**YARRA CITY COUNCIL**  
**Internal Development Approvals Committee**  
**Agenda**

**1.1 PLN16/1116 - 341-347 George Street, Fitzroy - Part demolition for the construction of a mixed-use building and a reduction in the car parking requirements**

1. This report provides Council with an assessment of Planning Permit Application PLN16/1116 which affects the land at No's 341-347 George Street, Fitzroy. The application is for part demolition for the construction of a mixed-use building and a reduction in the car parking requirements.

Decision plans before design revisions.

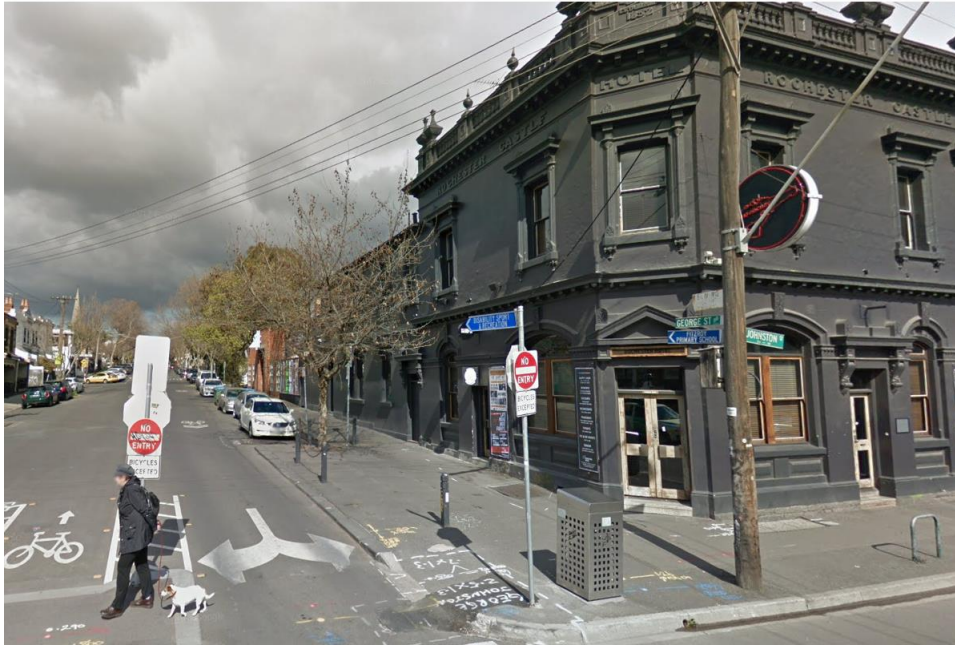
102. The urban design advice was predominately concerned with the appearance of the building behind these dwellings and requested the deletion of a level to allow for a more appropriate height transition. In response to this concern, the applicant submitted sketch plans changing the material colour of level 3 to a dark colour and the inclusion of a number of timber batten shading screens to the upper levels to further articulate these levels.

103. The urban designer reviewed the revised design and advised the introduction of the grey cladding to level 3 allowed for a 'negative level' /obscuring of this level behind the boundary walls with the upper levels predominantly appearing as two levels above the street wall (images below showing design before and after introduction of the grey cladding and timber screens). The inclusion of the shading screens to articulate the upper levels, along with the capacity to the rear of the single storey Johnston Street dwellings for further development would obscure the northern wall. For these reasons, the urban designers now support the development at seven storeys, as follows:

- (a) *We are supportive of the proposal in terms of adopting a defined 3 storey brick base with a setback upper form and the use of a different architectural language. The retention and reuse of the heritage façade and base is supported and is further enhanced by the employment of a 'negative' level to distinguish new and old form (within the base) and results in the provision of a DDO10 complaint base. We were previously critical of the rather simple (bland) architectural expression of Levels 3-5. The revised proposal has now appropriately addressed our concerns by way of introducing a distinct treatment to Level 3, comprising a different and darker lysaght steel cladding colour. This assists in visually recessing Level 3 and introduces a distinction to Levels 4-5 which are expressed as a 'pair' levels. This revised presentation results an acceptable architectural expression viewed in the backdrop of Johnston Street.*
